**Economic Commission for Europe**
**Inland Transport Committee**
**World Forum for Harmonization of Vehicle Regulations**
**Working Party on Passive Safety**
**Seventy-fourth session**

**Report of the Working Party on Passive Safety  
 on its Seventy-fourth Session**
**Contents**

Figure 1-2  
**Timeline for Dynamic, Static Time Constraint and Static Testing Representing Real Life Conditions**

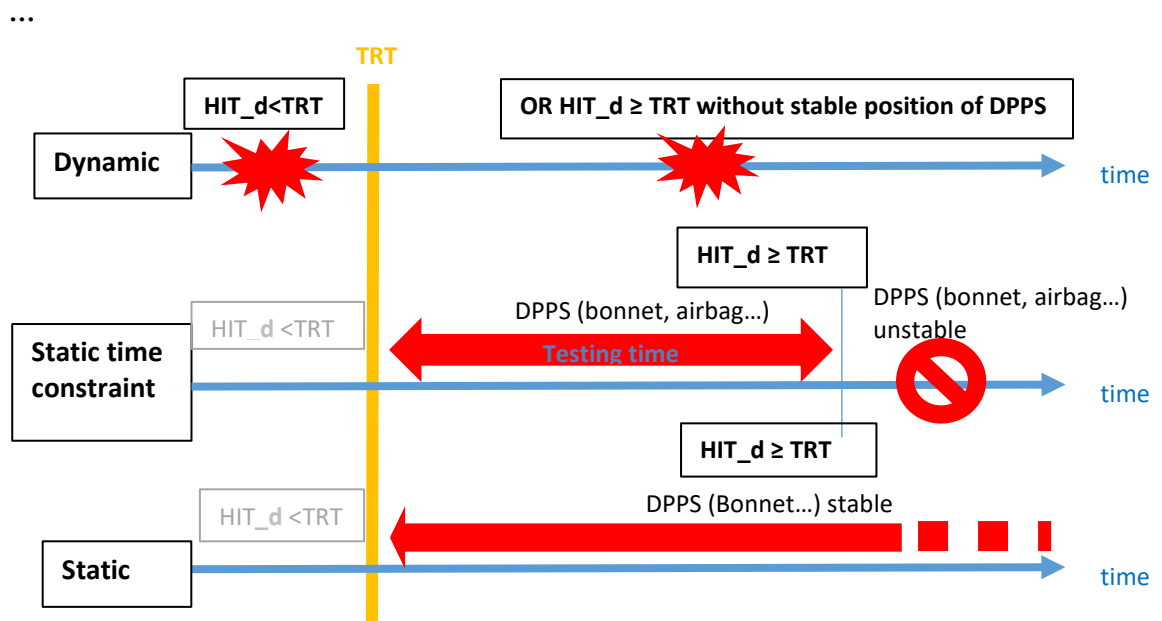
- 4.2.1.2. To enable dynamic testing to be conducted,  $HIT_s$  and **ST** are required
  - ...
  - (b) ST ... at **the vehicle centreline (Y0).**
- 4.3. **"Combined" test option:**
  - ...
  - If ..., as in the A section in ... as in the B section in Figure 1-1, ...

Figure 1

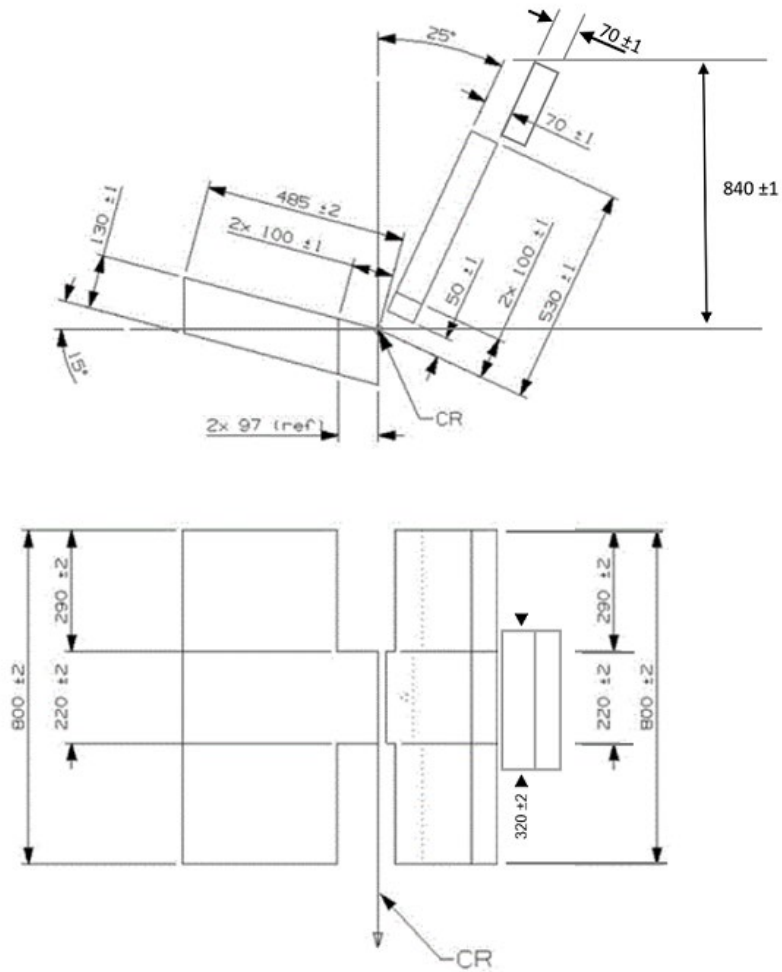
#### **"3.4. Optional dummy protective device**

**An optional dummy protective device may be installed on the test bench for the dynamic frontal test of booster cushion when tested on the test bench described in this Annex.**

Insert new Annex 6 – Appendix 5, to read:

**The dimensions of the dummy protective device are given in Appendix 3 of this Annex.**

**The forward face of the dummy protective device shall be parallel with the back of the backrest. The design of the dummy protective device shall be such that it does not interfere with the manikin when positioned on the test bench. Furthermore, the dummy protective device shall not interfere with the dummy and/or the adult 3-point belt during the dynamic test until the maximum horizontal head excursion has been reached.**
